**THE NETWORK RAIL (OLD OAK COMMON GREAT WESTERN MAINLINE TRACK
ACCESS) ORDER**

REBUTTAL EVIDENCE

NICHOLAS GALLOP BSc

SUBMITTED ON BEHALF OF BELLAVIEW PROPERTIES LTD

Figure 1 Hitachi North Pole Depot eastern internal level crossing (west of Mitre bridge) showing crossing warning lights and half barriers (circled) and STOP highway markings

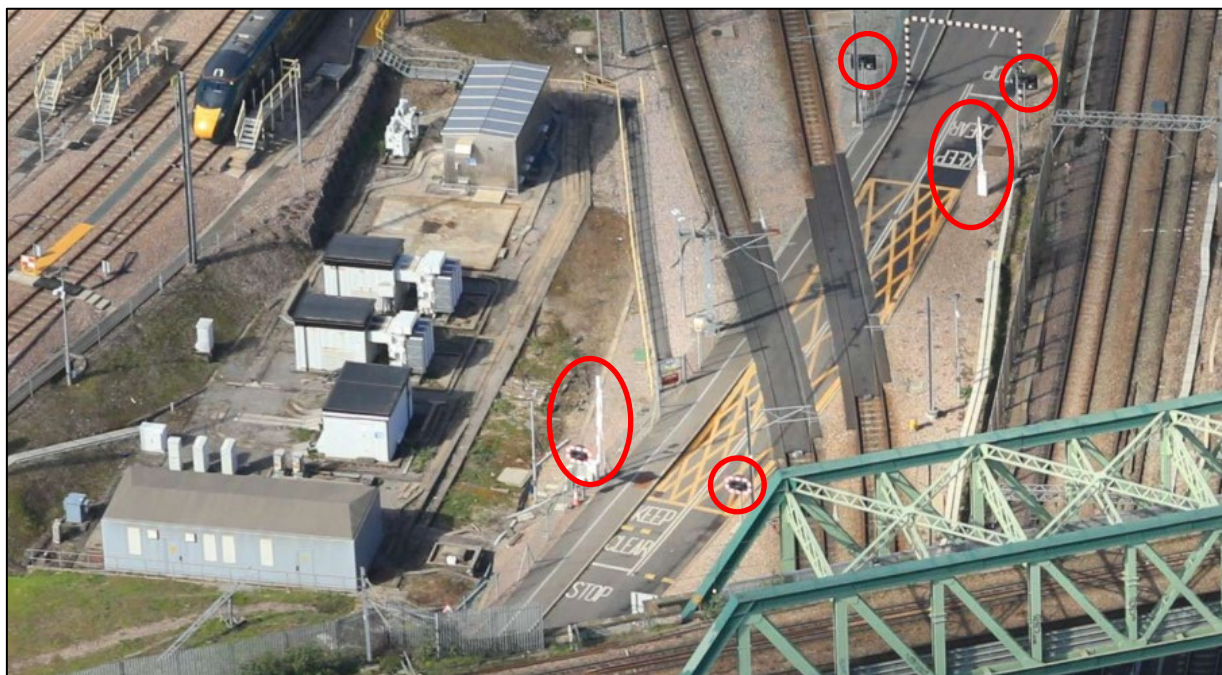
2.5 This plan shows how the existing Barlby Gardens RRAP would be used alongside proposed RRAP(s) inside the Hitachi Depot area, instead of the use of the temporary RRAP at Horn Lane, interconnected via the existing private internal road access and two existing internal level crossings (Figures 1 and 2 below), connected in turn to the external highway network. The two separate main line access points to the GWML and WLL could be used as required to maintain access for passenger trains on and off the depot. If the access to GWML Main Lines is to be blocked to GWR trains for OOC construction works (noting this will be planned months in advance) trains can either be outbased at other depots for the duration⁸ and/or use could be made of the WLL main line connection⁹ to maintain GWR trains access to and from the depot as described above.

- Restricted storage - see paragraphs 2.4, 2.5, 2.6 and 3.4 of this Rebuttal above;
- Crossing of internal rail tracks within the Depot – already addressed by Network Rail's previous assessment and by Mr Gent's Proof of Evidence, see also Figures 1 and 2 above;³⁰

Figure 3 Western end of Horn Lane site, showing HGV accessibility (source Google Earth)

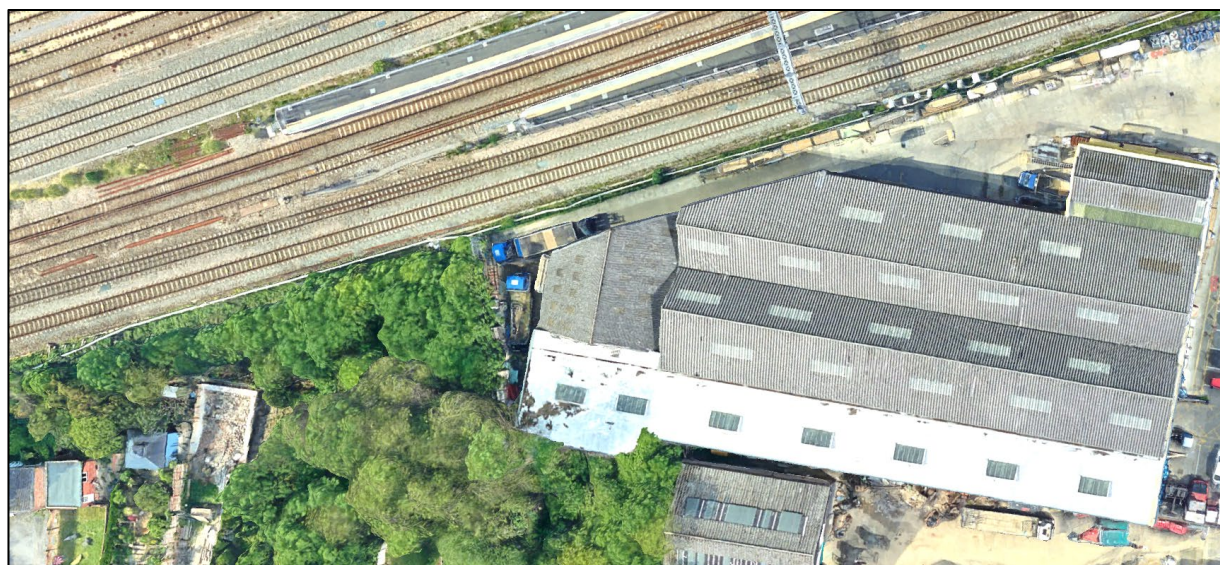
- 3.28 This has effectively been superseded by recent discussions between BPL, Colas Rail and Network Rail relating to the separation of access and storage functions. Network Rail has acknowledged that the issue related to the Triangle Site (isolation of the overhead electrification) could be rectified, which would then enable its use as a temporary and permanent RRAP, the latter then afforded greater potential as a result.
- 3.29 The “narrow path” between the Horn Lane site and the Triangle site would be of sufficient width to allow RRVs or maintenance vans to reach the RRAP itself, as highlighted by recent satellite imagery which clearly shows 2.5m wide HGVs parked in this area (see Figure 3 below).
